LIMERICK GENERATING STATION UNITS 1 & 2
ENVIRONMENTAL REPORT - OPERATING LICENSE STAGE

REVISION 12 PAGE CHANGES

THIS EROL SET HAS BEEN UPDATED TO
INCLUDE REVISIONS THROUGH 12
DATED 04/83.

FIGURE 7.1-2

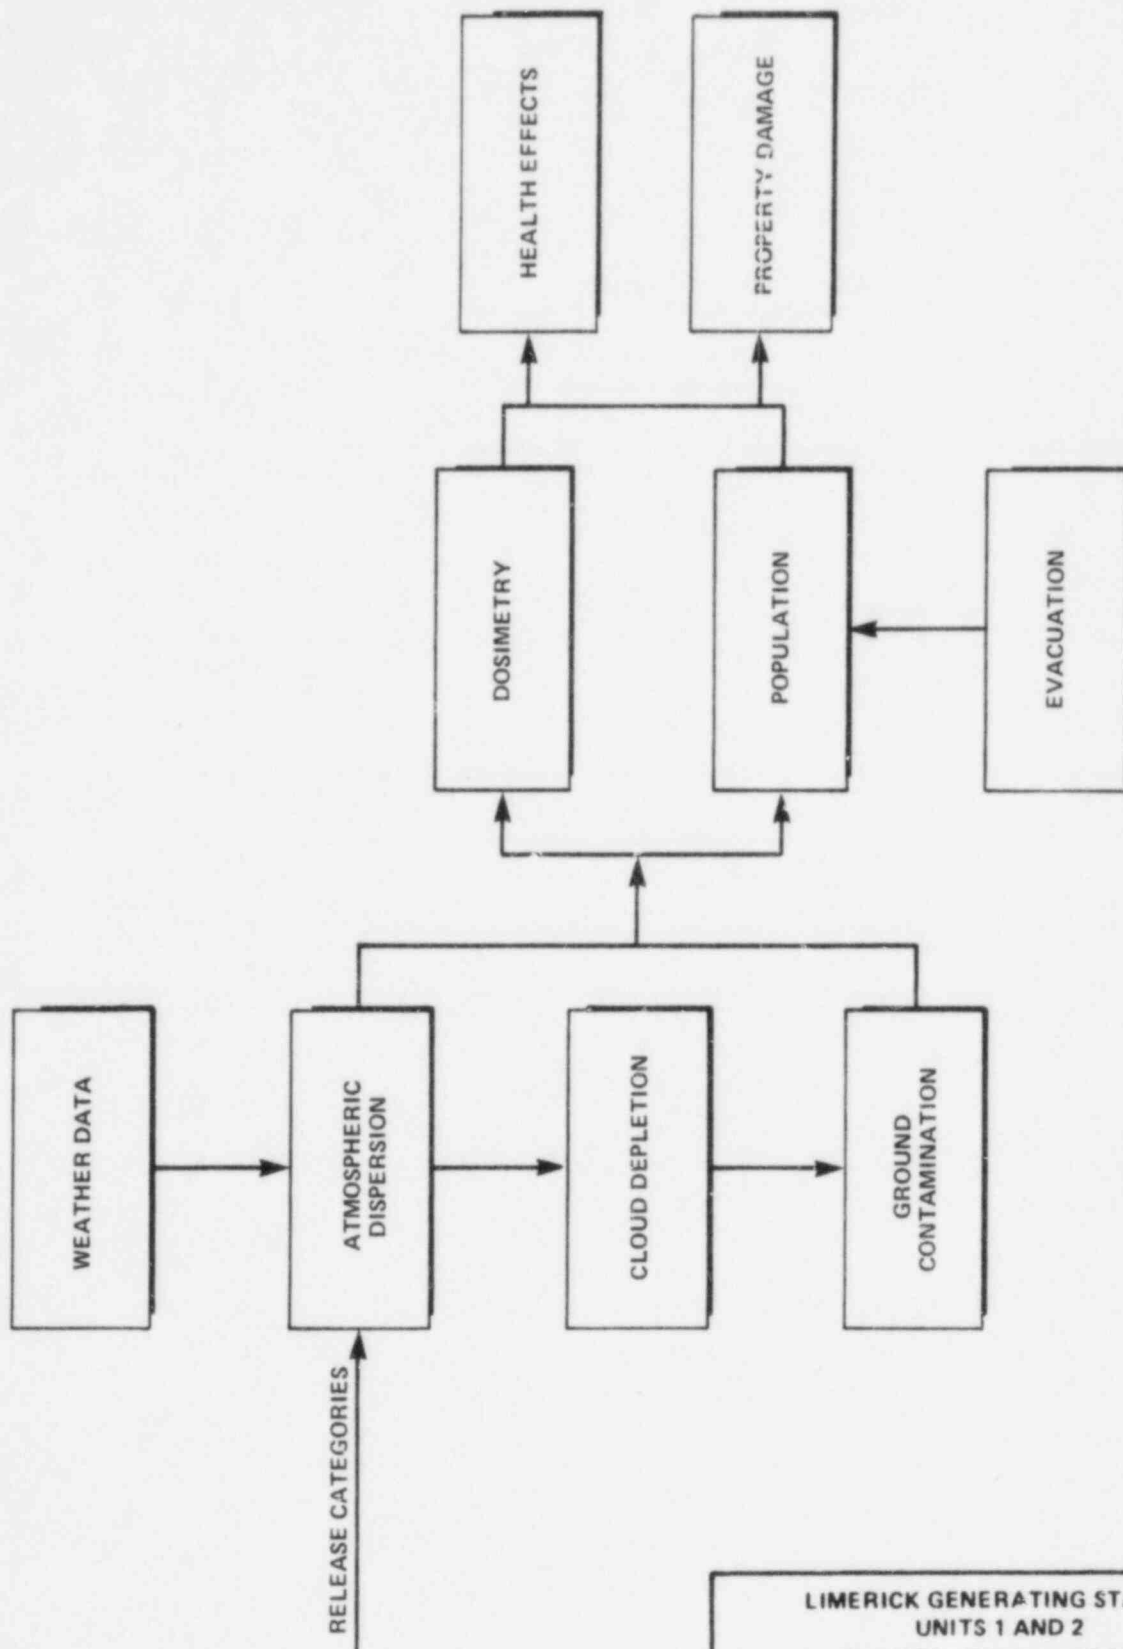
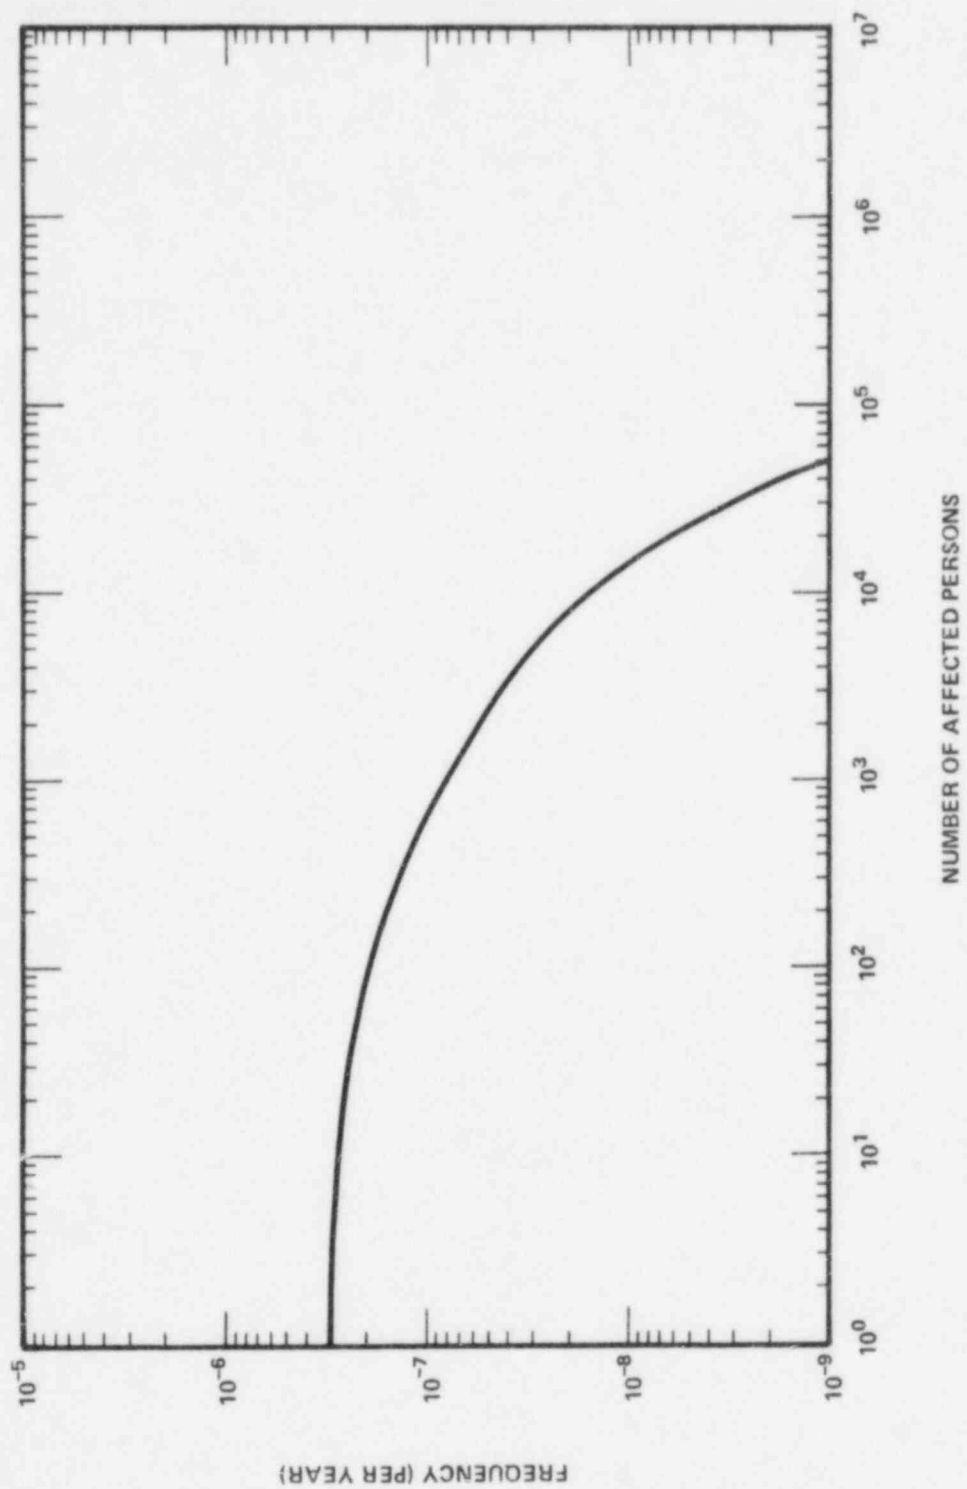
Figures 7.1-1 and 7.1-2 (the two CCDFs) have been superseded by subsequent PRA revisions; and therefore are no longer valid. Please provide updated information.

FIGURE E 290.16-1

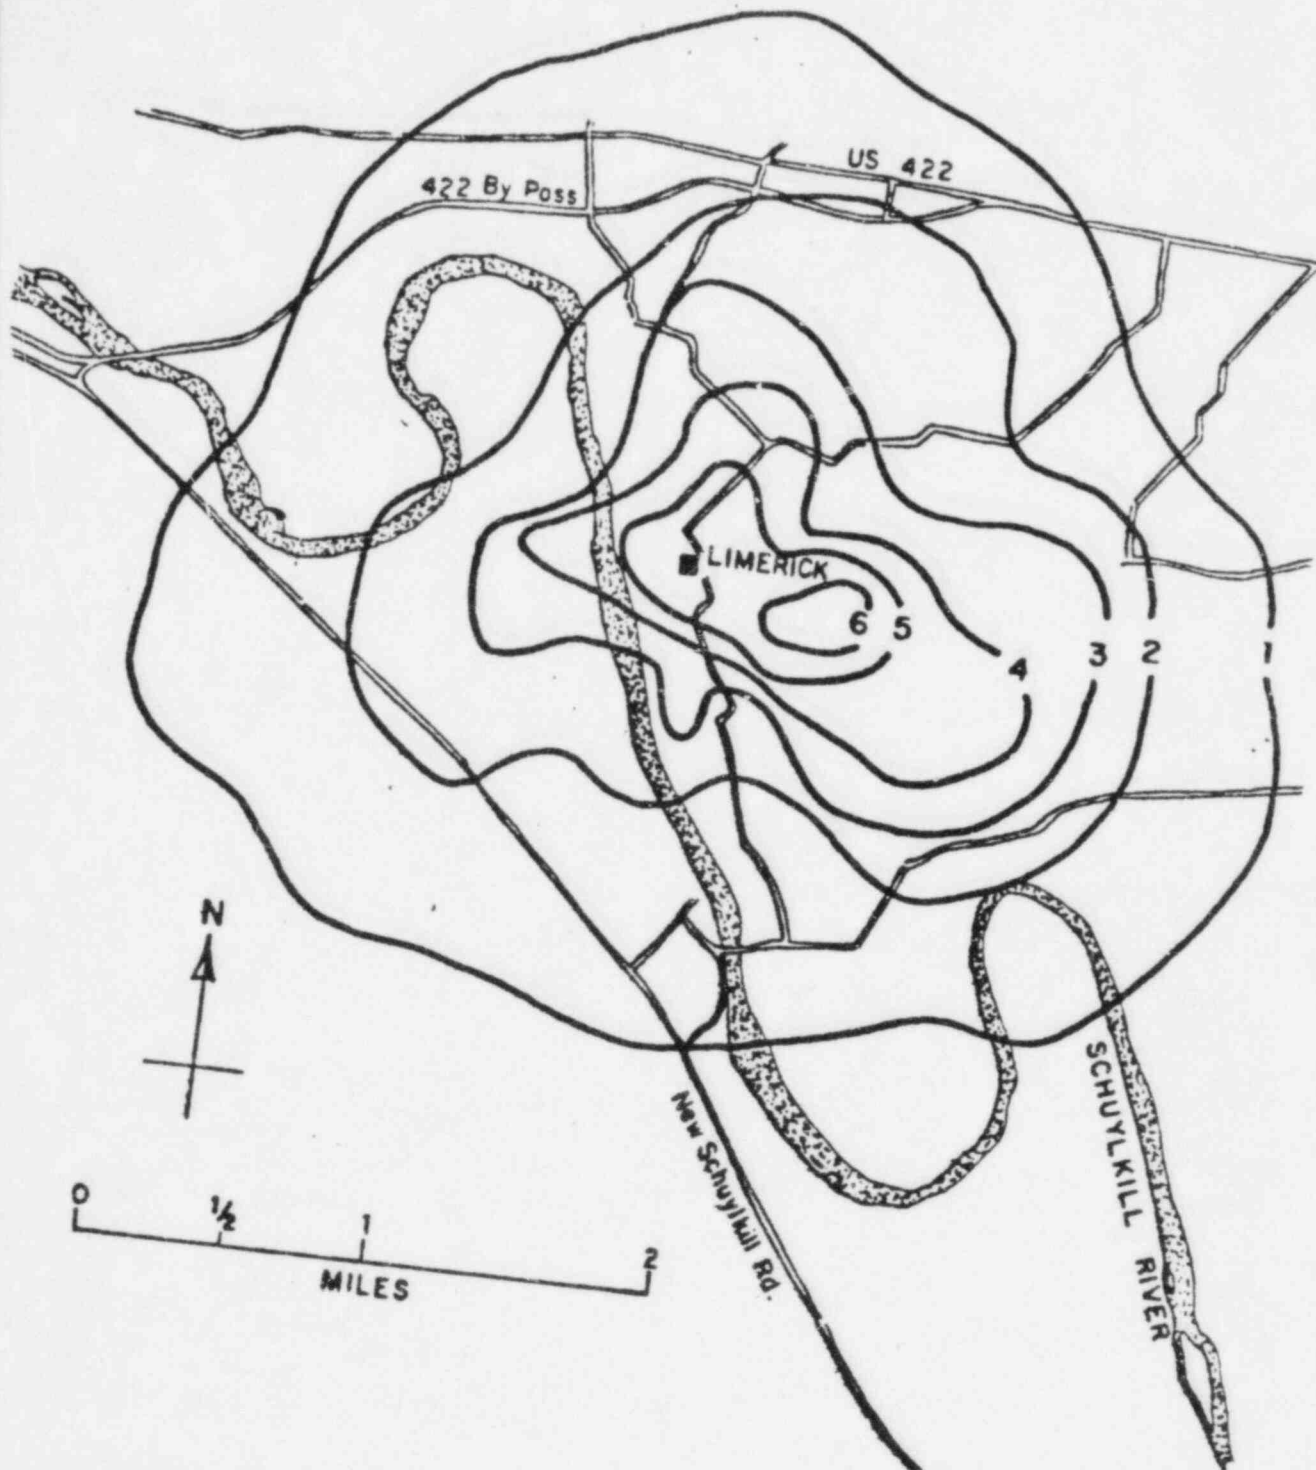
Provide a figure of the site and immediate vicinity showing salt drift deposition isopleths (lbs/Ac/yr) when both natural draft cooling towers are operating. Provide detailed information on the model used to predict the deposition including information on verification of the model.

A plot of annual average salt deposition isopleths in lb/acre predicted from the operation of the two natural draft cooling towers is shown in Figure E290.16-1. The predicted maximum deposition is 6.8 lb/acre/yr at a distance of 0.5 miles ESE of the plant.
